**APPLICATION
FOR PERCOLATION TESTING AND SITE EVALUATION**

Re: 12146 Mount Albert Rd.
Ellicott City, MD 21042
(Percolation Test Report)

PERCOLATION APPLICATION
12146 MOUNT ALBERT ROAD
WOODMARK
PART "B", SECTION N° ONE
LOT 45

PERCOLATION CERTIFICATION PLAN
12146 MOUNT ALBERT ROAD
WOODMARK
PART "B", SECTION "N" ONE
LOT 45

Attachment: Percolation Field Notes

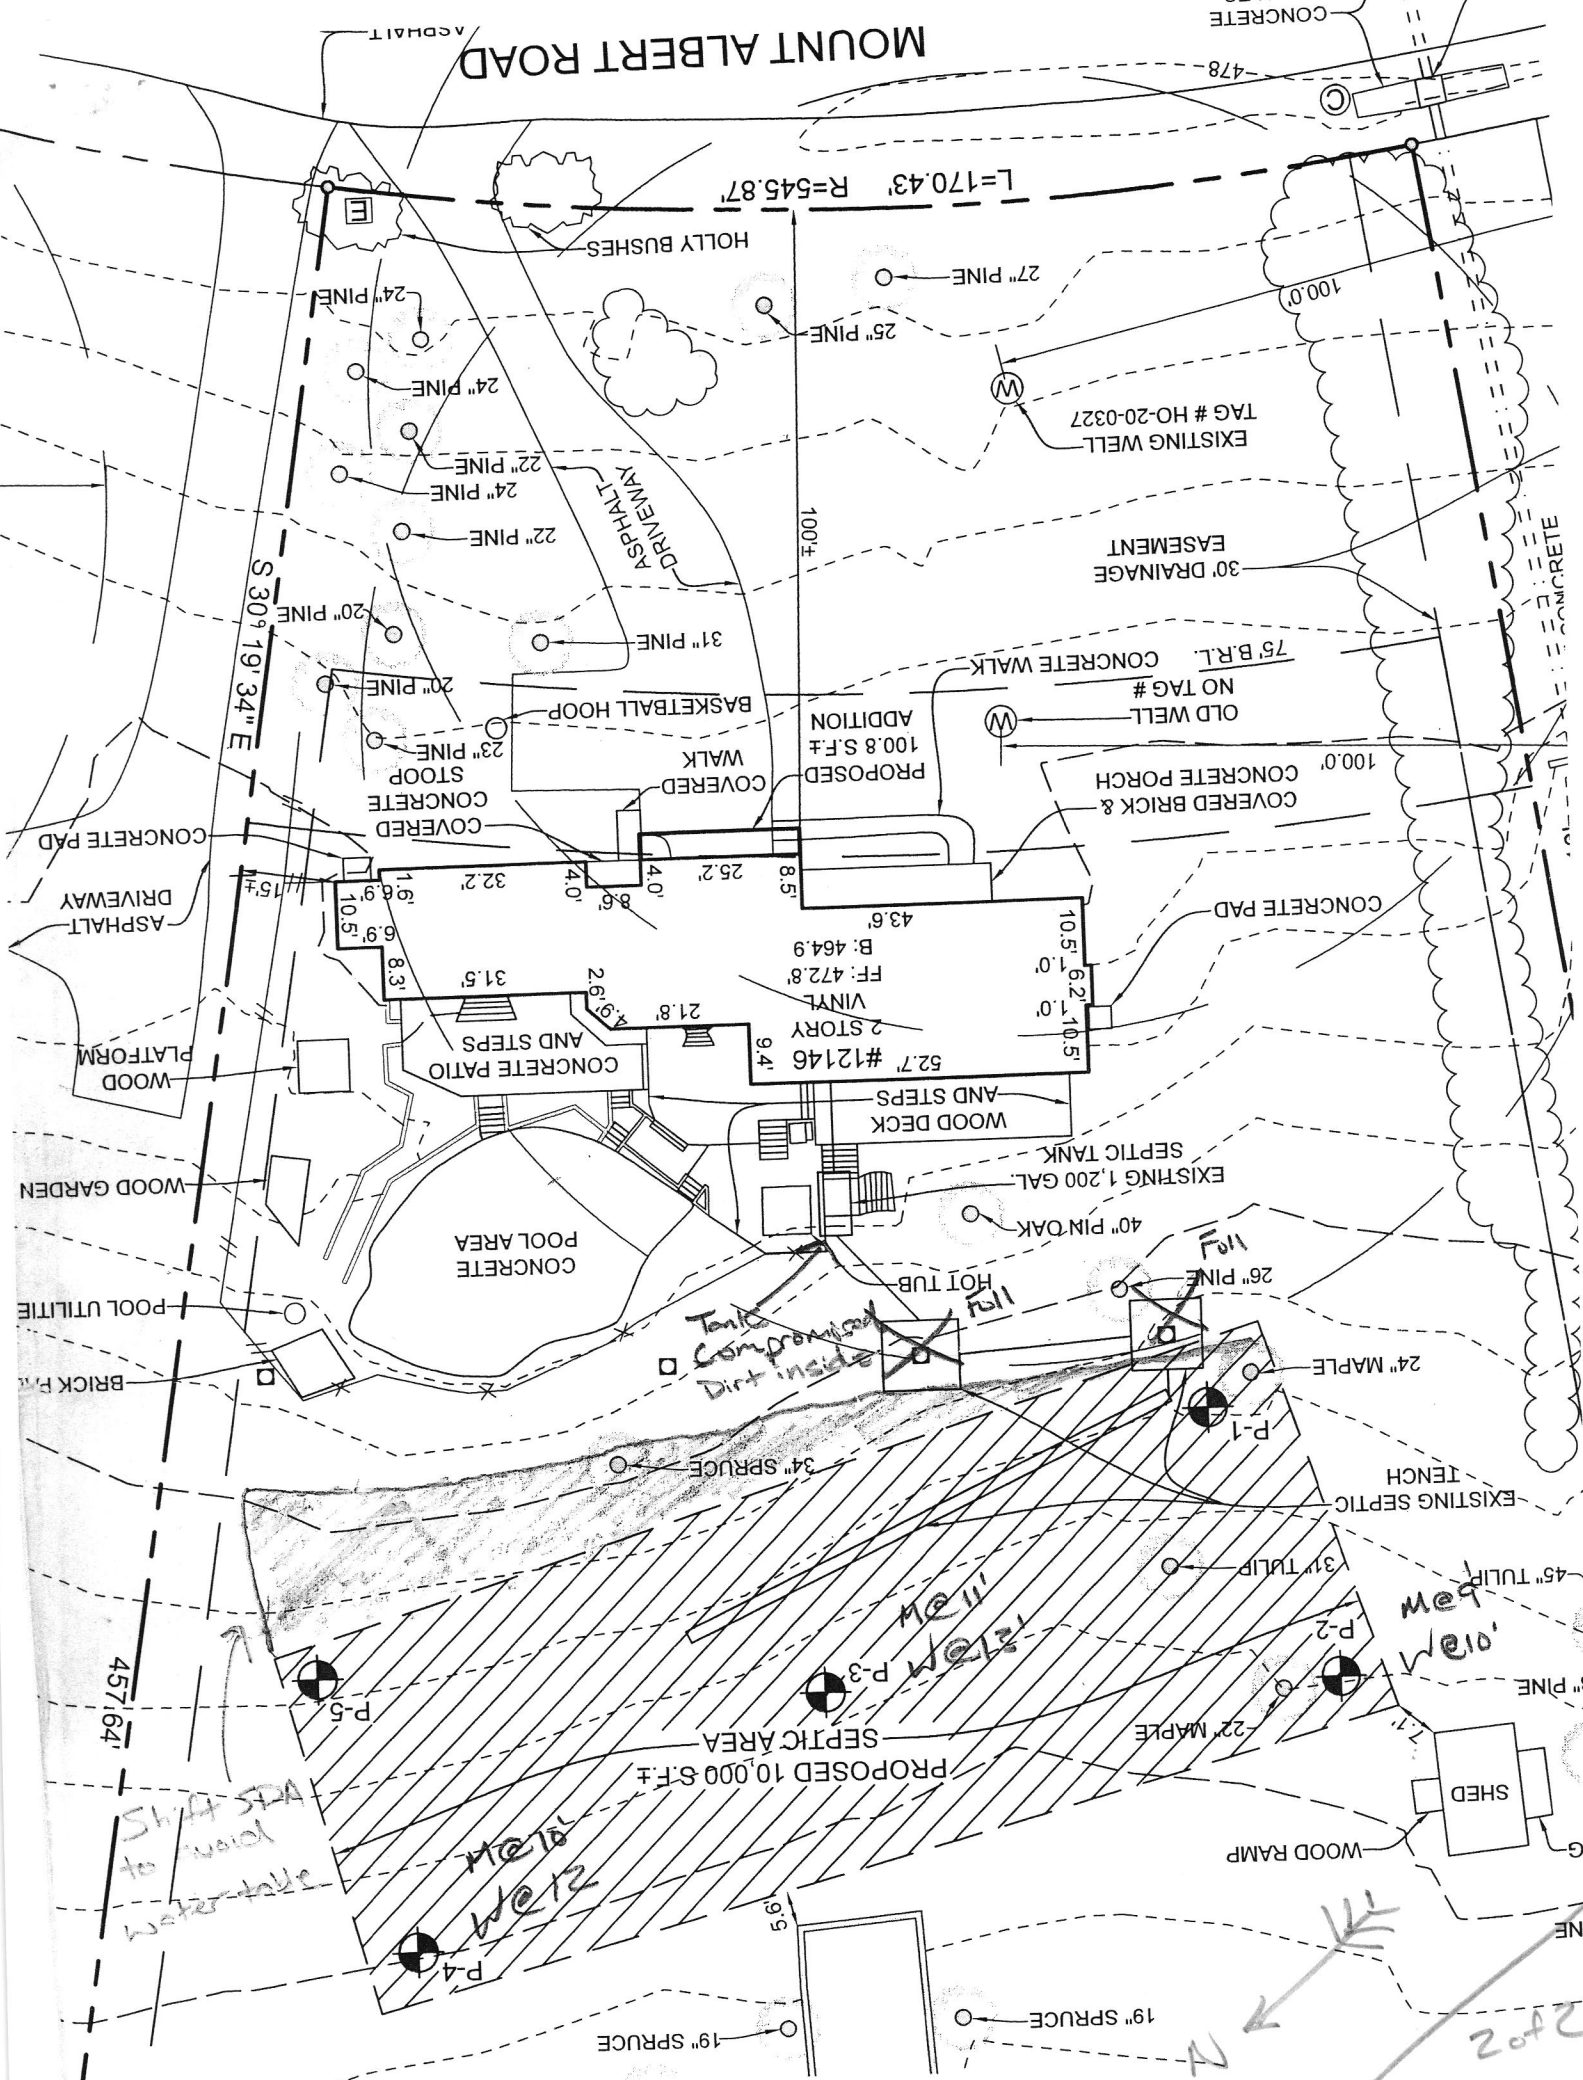
- Both Drivells 1' liquid to bottom of o/a

ST compromised dirt in tank under porch

- Trench beginning end end clean stone 3/4' - 8' probal

- Ground water @ 13' closest to ex. trench. Moist soil @ 11'. Ex. Trench does not meet 4' buffer required by MDE.

REMARKS Soil consistent between tests, Shift SDA closer to house

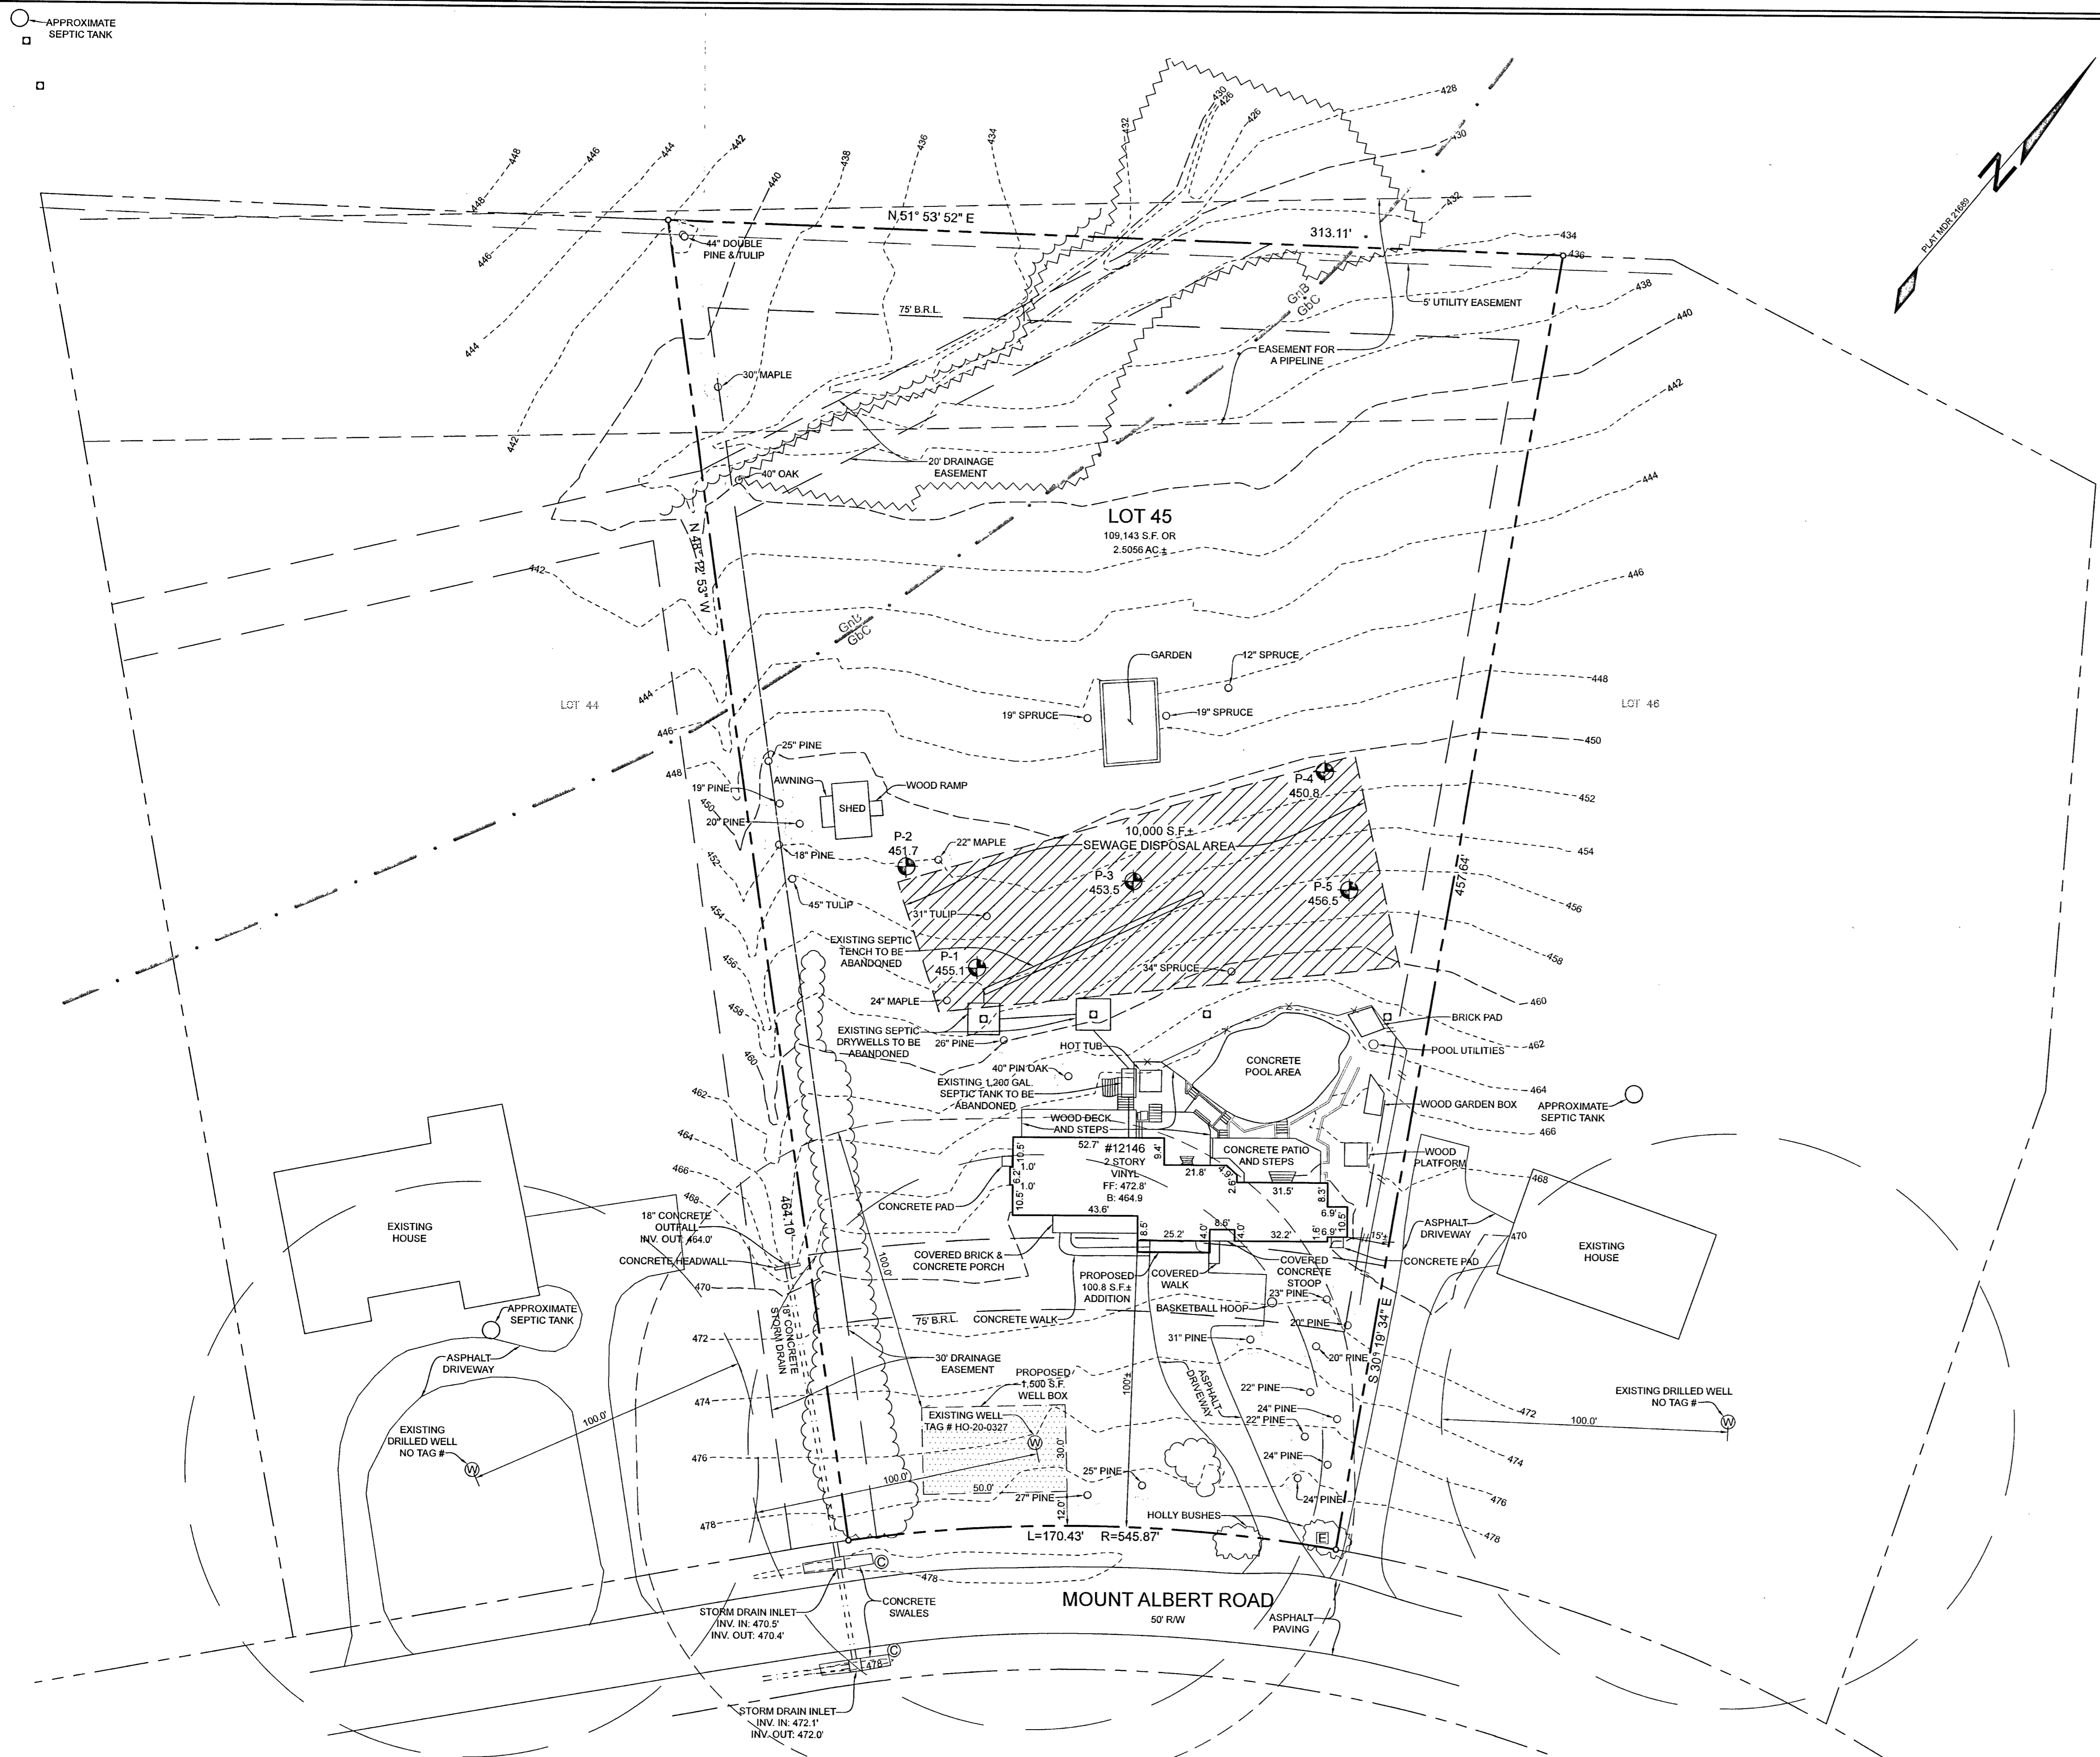
* Need to show neighbor houses & septic systems.

* Need to show stream and 100' ~~arc~~ distance from closest stream bank

* Missing replacement wells (few notes)
& 100' arcs

PERCOLATION CERTIFICATION PLAN
12146 MOUNT ALBERT ROAD
WOODMARK
PART "B", SECTION N° ONE
LOT 45

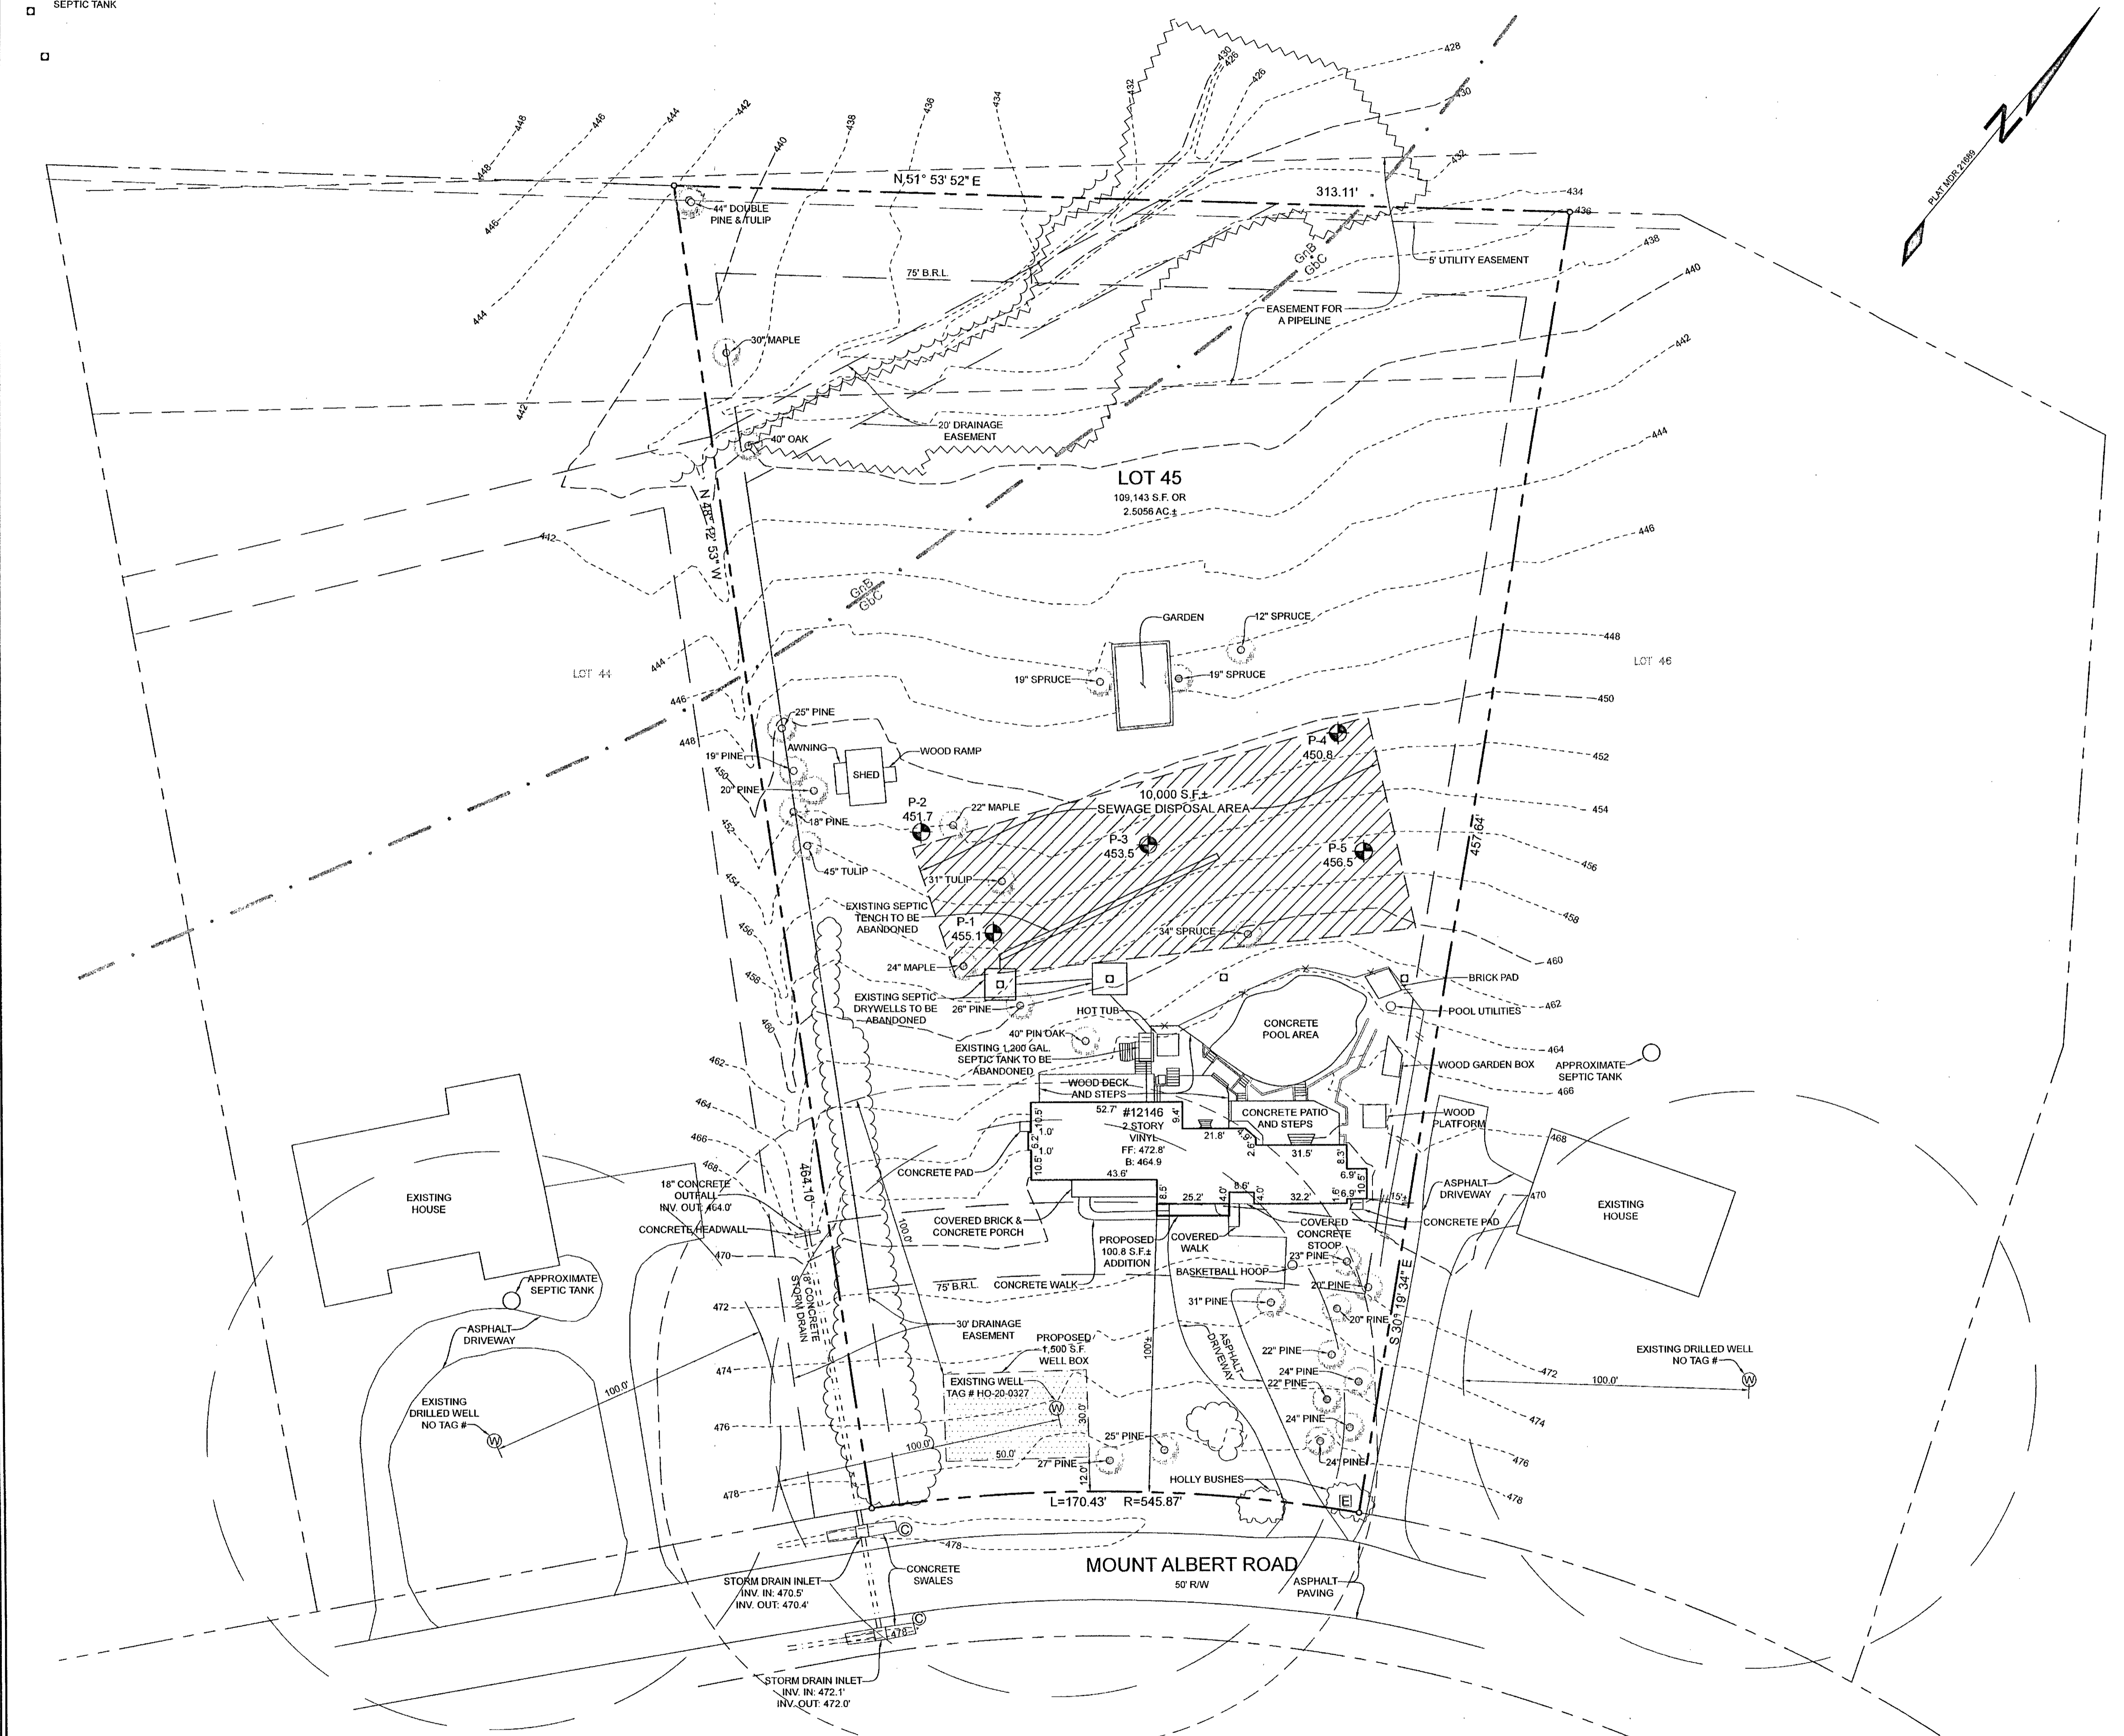
B25000410: Proposing second story addition 1200sqft, Percolation Certification Plan and OSDS Plan submitted. Requesting to reduce 20ft setback between a pool and the SDA to 10ft.

Regulation Section	Summary and Explanation
1. <u>Sec. 3.808(m)</u>	<u>SDA to pool setback 20ft</u>
2. _____	_____

approved in location shown on PC for existing pool to new SDA
